**RESPONSE TO
PLANNING
OBSERVATIONS**

**PROPOSED
REDEVELOPMENT**

**10 CHRISTCHURCH
HILL, HAMPSTEAD
LONDON NW3**

November 2014

13.00 Existing
13.00 Proposed

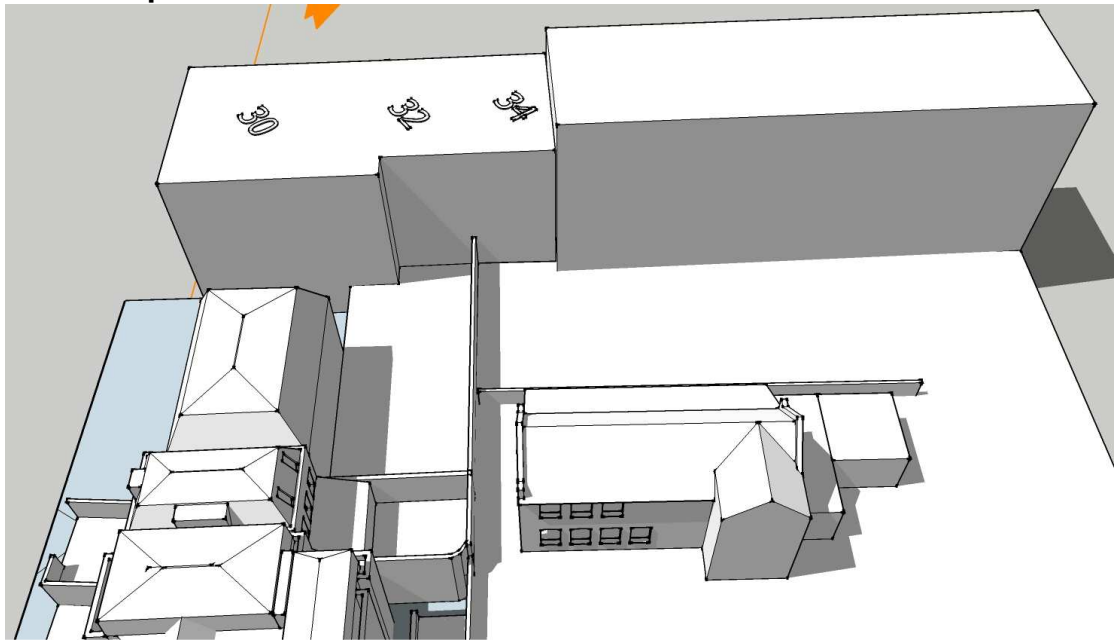
- The proposed development with its higher roofline which continues for a longer length (perpendicular to Christchurch Hill) and is also wider (parallel to Christchurch Hill), will impact the light at the back of 34 Well Walk, both in respect of the rear ground floor windows and also the patio, and will be especially acute during the Autumn to Spring months when the sun is lower and natural sun light is already somewhat limited. The Daylight & Sunlight Report submitted for this application is at a time of year which seems to drastically underestimate the effect of the proposed building given the sun is much higher in the sky in the period analysed vs. the Autumn to Spring months.
- The proposals will impact on light levels on the front gardens of nos. 13 and 14 Gainsborough Gardens and the rear gardens of 11, 12 and 13 of the same street.

As regards 34 Well Walk, it is averred that our analysis was made at an adjusted time of year to improve the apparent effects on the rear of this building and “to drastically underestimate the effect of the proposed building”. This is not the case as the initial shadow diagrams were compiled for the Equinox (21st March and 21 September). In response to this allegation, however, we have compiled proposed and existing analyses of the situation at the rear of 34 Well Walk at hourly rather than two-hourly intervals and at the Equinox, Midsummer’s Day (21st June) and Midwinter’s Day (21st December). These are set out below.

As can be seen from these images, there is no effect whatever on the sunshine reaching the rear of 34 Well Walk or its patio caused by the proposals on either Equinox nor Midwinter’s Day nor Midsummer’s Day. The assertion made is, therefore, without any foundation whatever and our original report does not underestimate the effects, drastically or otherwise, of the proposed building.

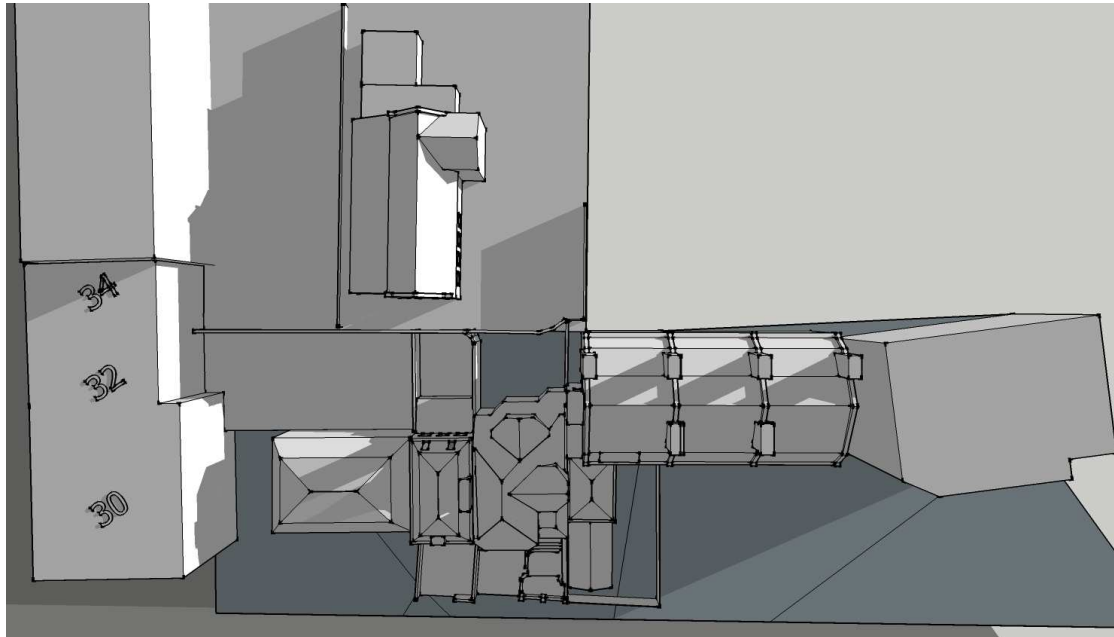
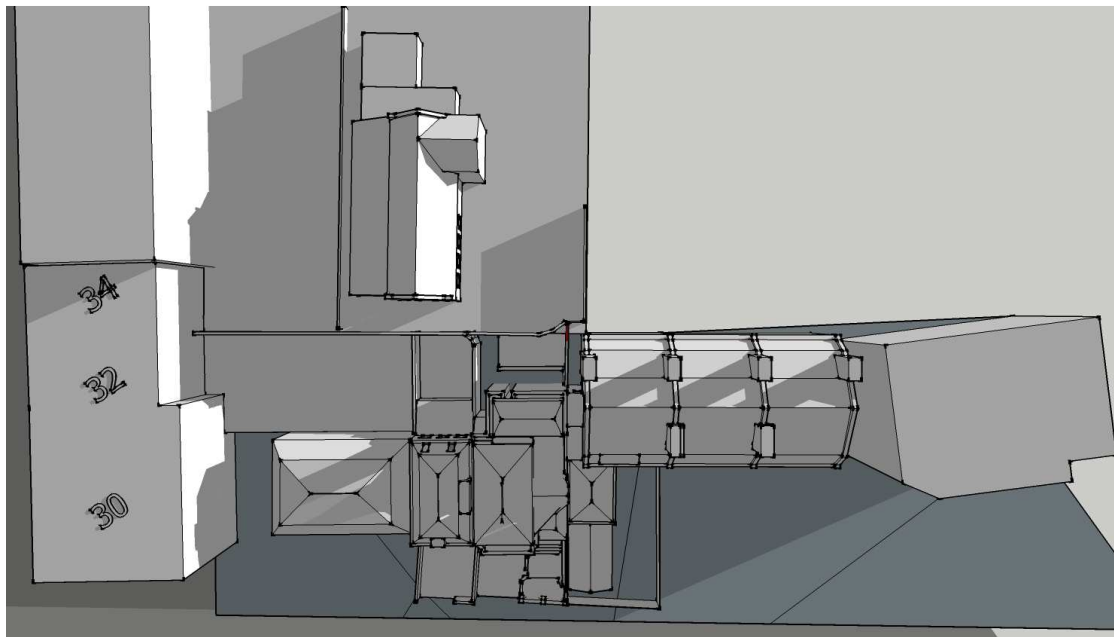
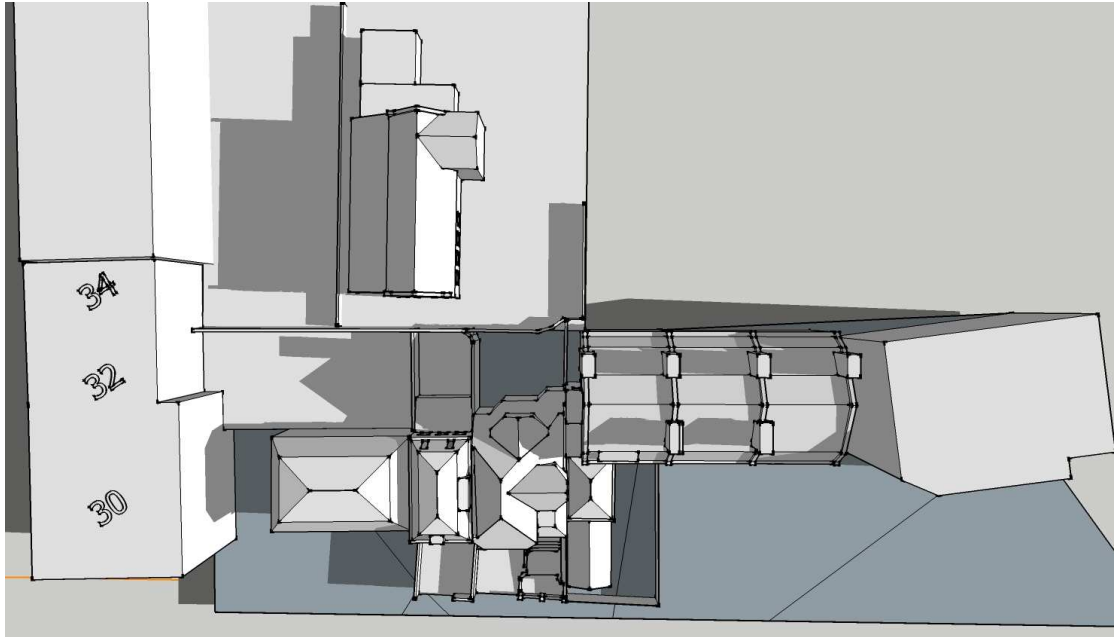
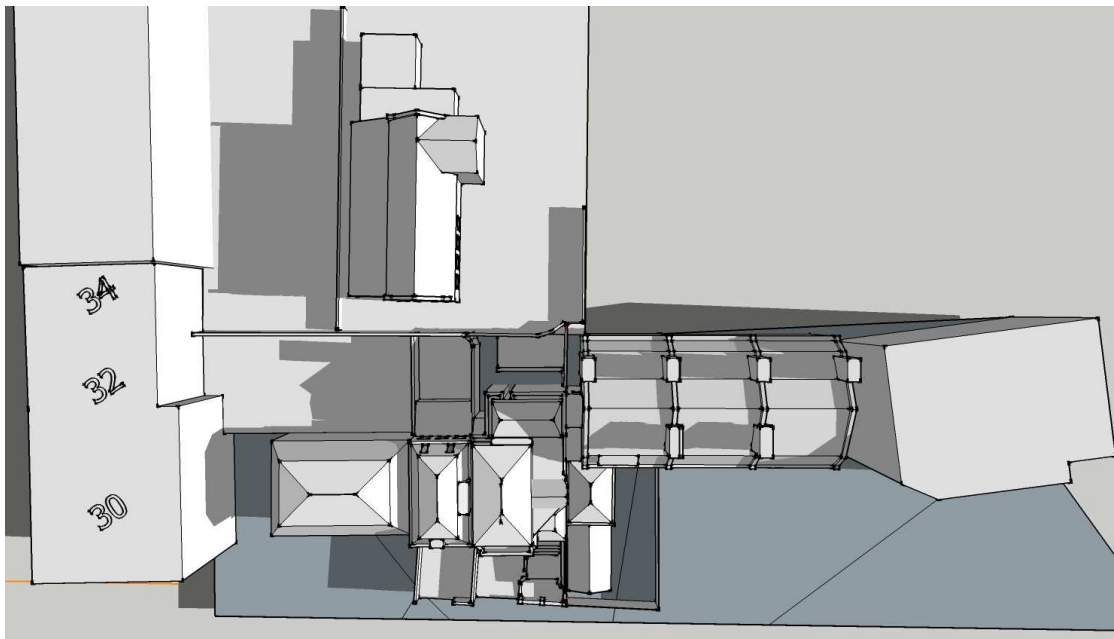
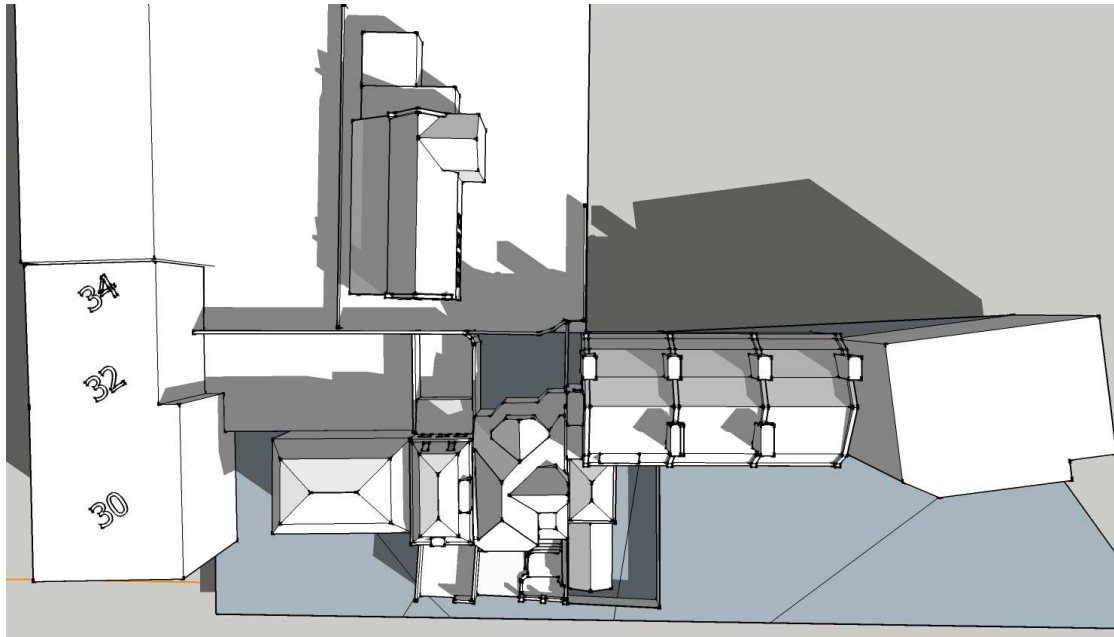
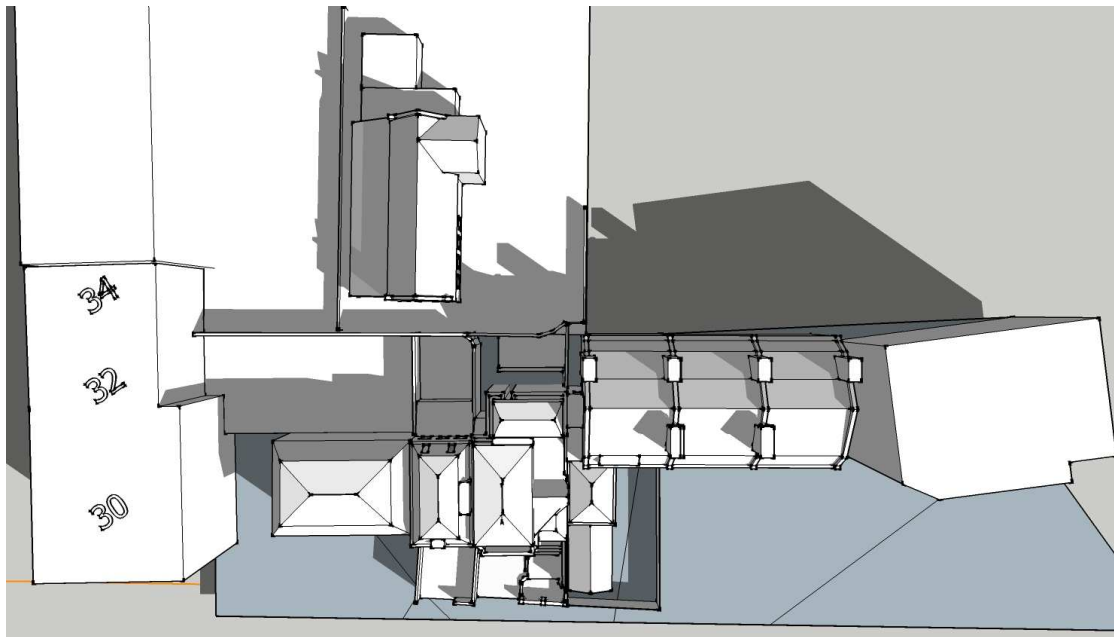
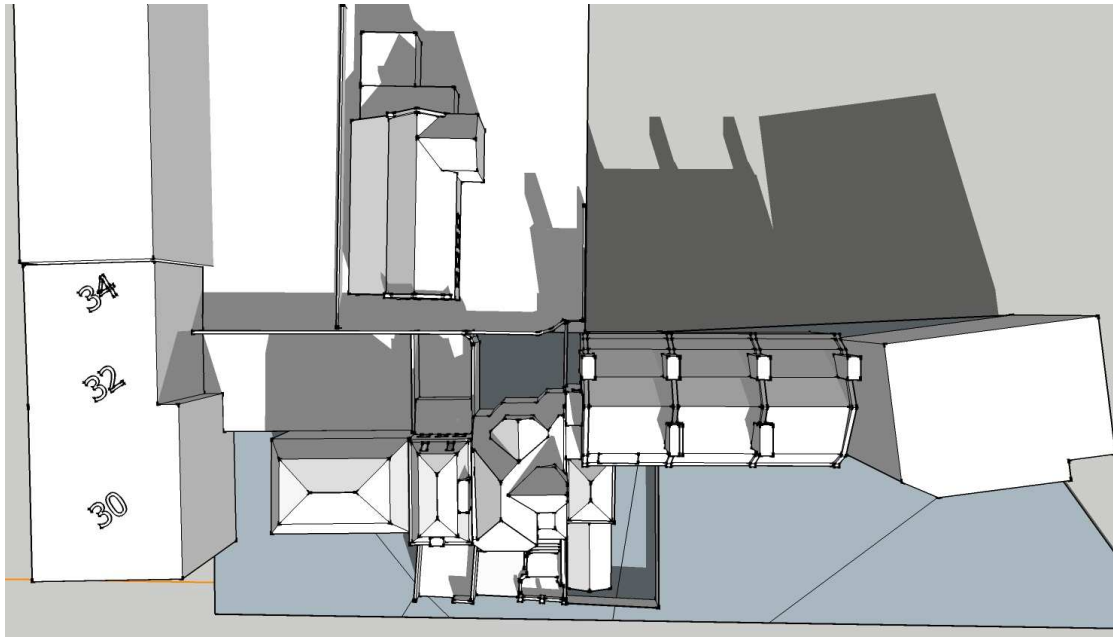
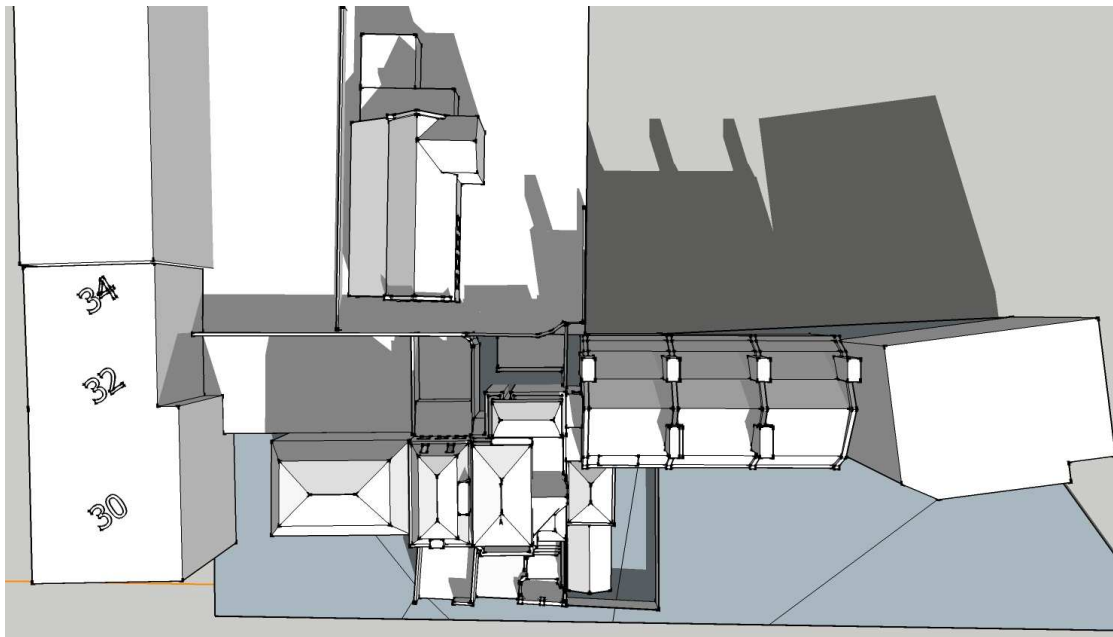
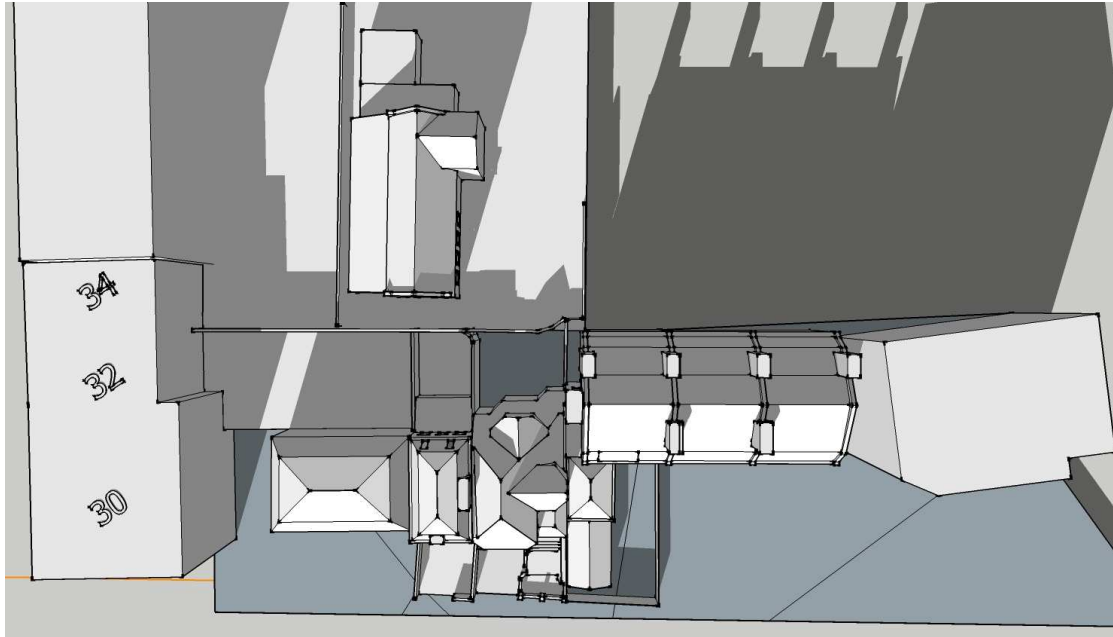
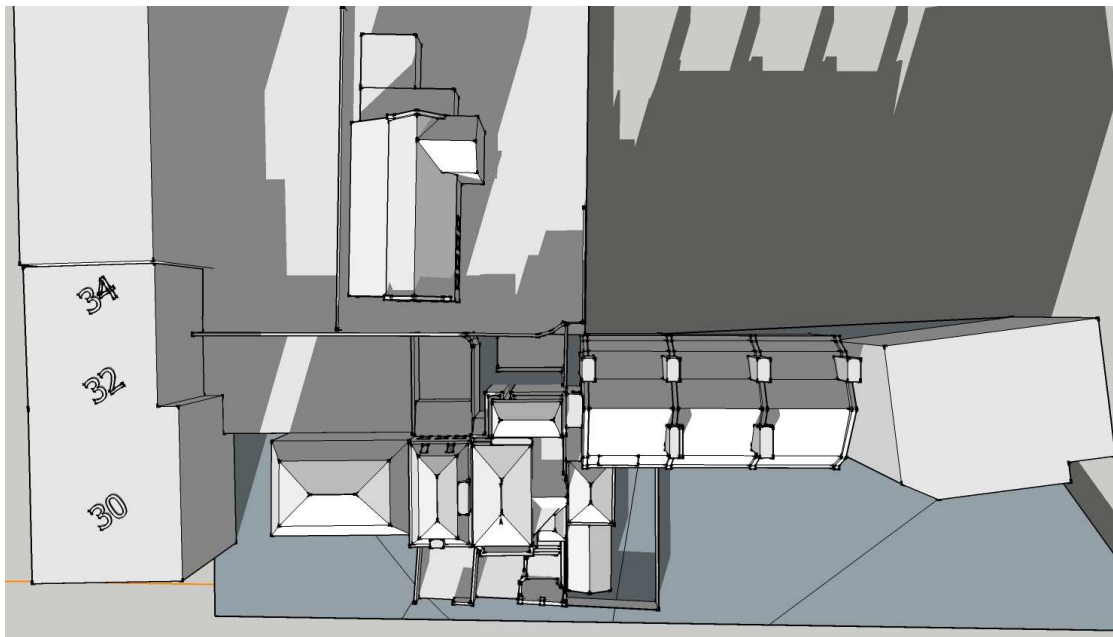
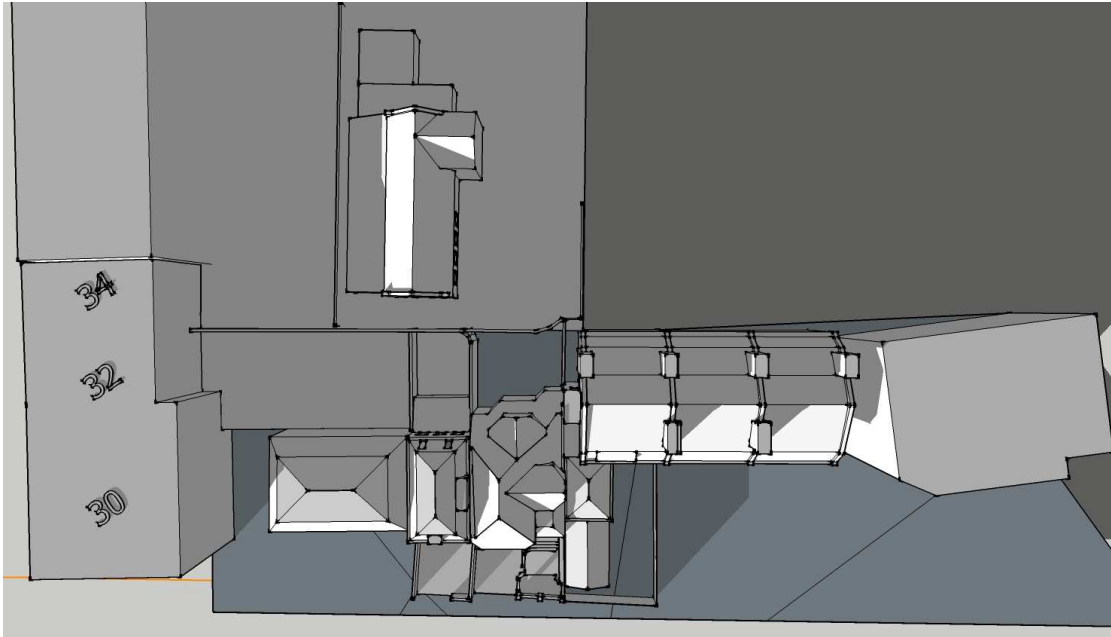
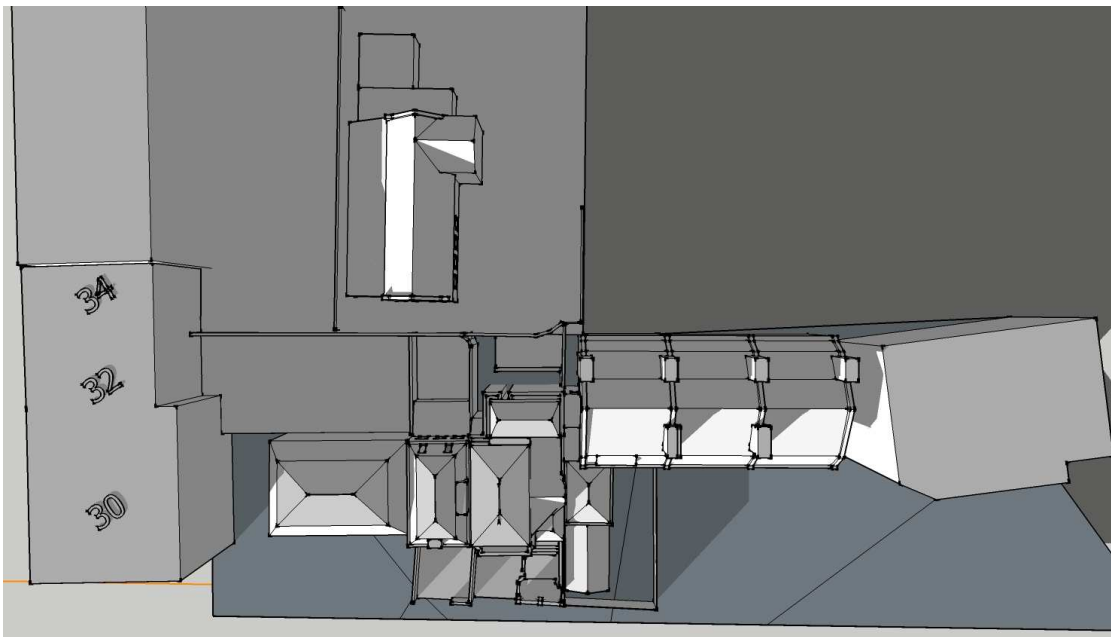
It has been averred that the proposals will have significant effects on the front gardens of 13 and 14 Gainsborough Gardens and the rear gardens of 11, 12 and 13 Gainsborough Gardens. The BRE Guide sets the criterion that the sunlight reaching gardens and other sitting-out areas should not be reduced to less than 2 hours over 50% of the area on the Equinox. We have, therefore, set out a series of shadow diagrams below at two-hourly intervals showing the cast of shadows as existing and as proposed.

As will be seen from this sequence, there is a slight effect on the rear garden of 32 Well Walk at around 09.00 but half of this garden will still retain 2 hours' sunshine on the Equinox. There will also be some additional shadowing in the garden of 14 Gainsborough Gardens but well in excess of 50% of this garden can be seen to benefit from over 2 hours' sunshine. The gardens to 11, 12 and 13 Gainsborough Gardens are completely unaffected by the proposals, even at 17.00 hours. Thus, the proposals do not breach the overshadowing criteria set out in the BRE Guide as alleged or at all.
